HORSHAM DISTRICT COUNCIL CONSULTATION

TO:	Horsham District Council – Planning Dept
LOCATION:	Land at Sumners Ponds Chapel Road Barns Green West Sussex
DESCRIPTION:	Application for Approval of Details Reserved by Conditions 18 and 19 to approved application DC/21/2697
REFERENCE:	DISC/25/0395
RECOMMENDATION:	Holding Objection / More Information / Modification
SUMMARY OF COMMENTS & RECOMMENDATION:	
We are satisfied with the information provided in order to discharge Condition 19, however more information and modification is requested in regard to Condition 18. Key concern remains with the diluted landscape strategy in contrast to approved plans under DC/21/2697 and those submitted under DC/25/1251, in addition to the fact that 8 trees of the current layout are unlikely to be able to be delivered due to conflicts with underground services. It is welcomed that 8 additional trees have been added to the planting schedule since the previous proposals under DISC/25/0116, however, we have identified 8 trees that can no longer be delivered due to conflicts with the drainage and lighting strategies. There has also been a reduction in extra heavy standard specimens, which were previously reque

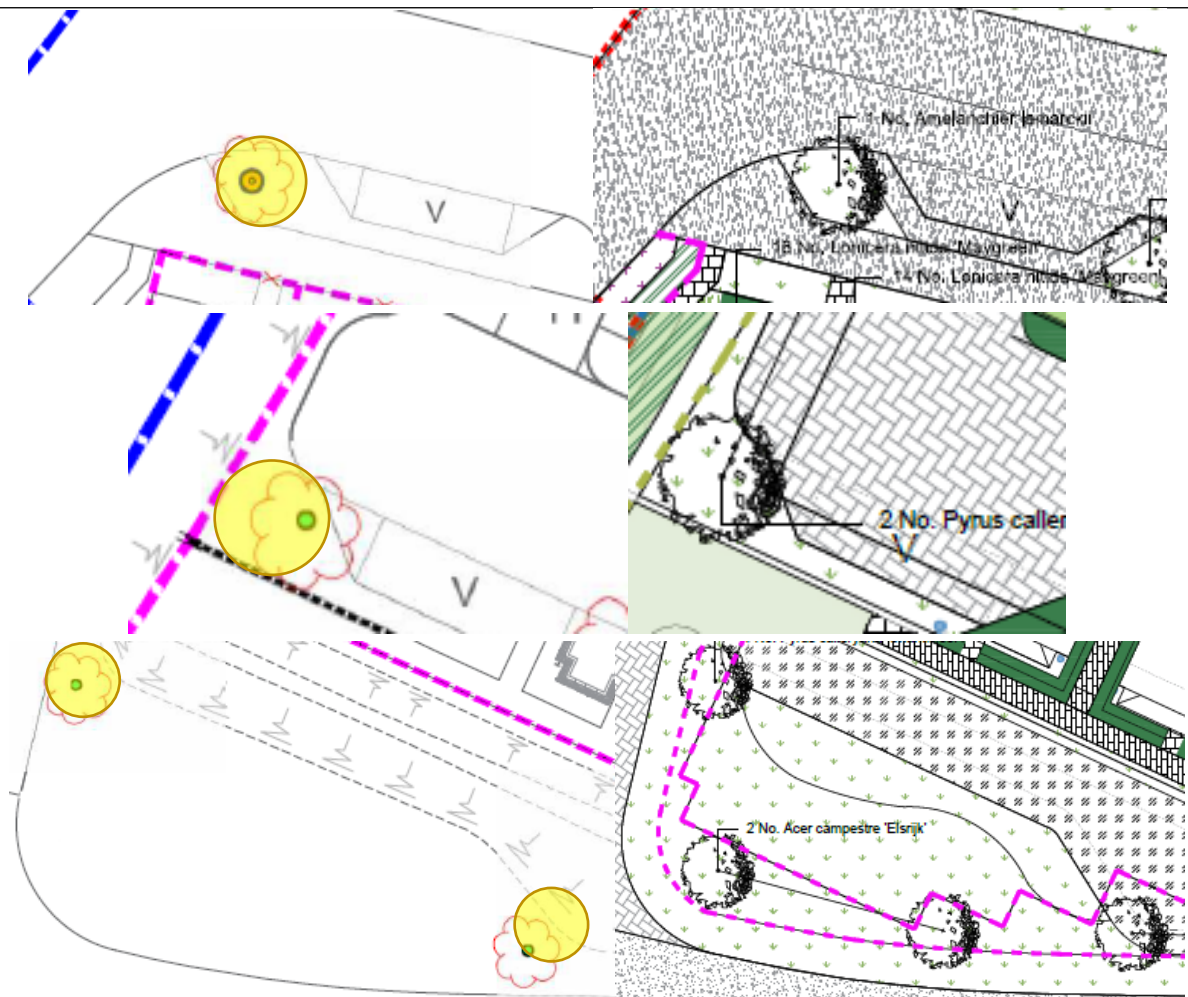
- ii. Details of all proposed trees and planting, including schedules specifying species, planting size, densities and plant numbers and tree pit details
- a. The landscaping proposals have been coordinated with the attenuation tank locations, with thanks, however they remain uncoordinated with the drainage strategy. We note various conflicts with drainage runs, therefore we request the strategies are coordinated and that trees are re-located to ensure they can be delivered. Please see examples highlighted below. **Sigma-LVIA comments-** See updated plans issued now, the trees have been moved or removed as needed. We are confident we can deliver this proposal with the adjusted position and species specified.

- b. As above, the landscape strategy must also be coordinated with the lighting strategy, ensuring that utility runs are indicated in addition to fixtures to ensure no further conflicts. Current areas of proximity and/or potential conflict are highlighted below and modification is thus requested. **Sigma-LVIA comments-** See updated plans issued now, the trees have been moved or removed as needed. The Street Lights (low level bollard lights, have been adjusted in position to coronated where needed.)

- c. Please reinstate tree adjacent to plot 7, highlighted in red below. **Sigma-LVIA comments-** See updated plans issued now, this has been added.

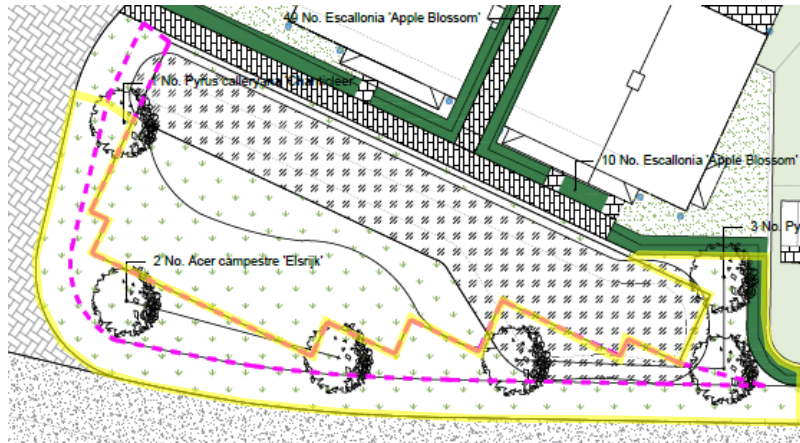
- e. As above, please amend the root barrier within the central green to avoid drainage runs and to align with the road to increase available rooting medium. See suggestion below in yellow. **Sigma-LVIA comments-** This cannot be provided as it covers the service margin. As discussed in our meeting and with Utility-Services route drawings

tables, there is a services route along this zone, hence the root barriers alignment to protect both and the underground tanks. We cannot move the root barrier as we are governed by the utility-service provide along this zone.

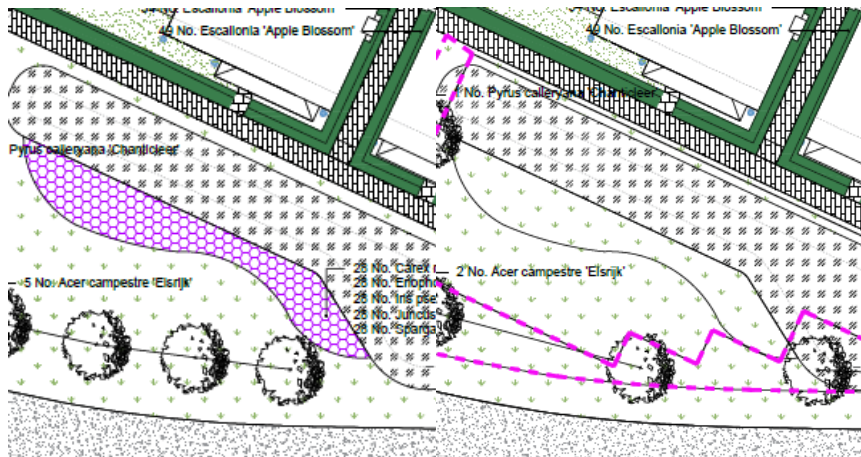
- f. Please reinstate marginal planting mix as reflected in previous proposals. [DISC/25/0116 below left, current application below right] *This has been added.*
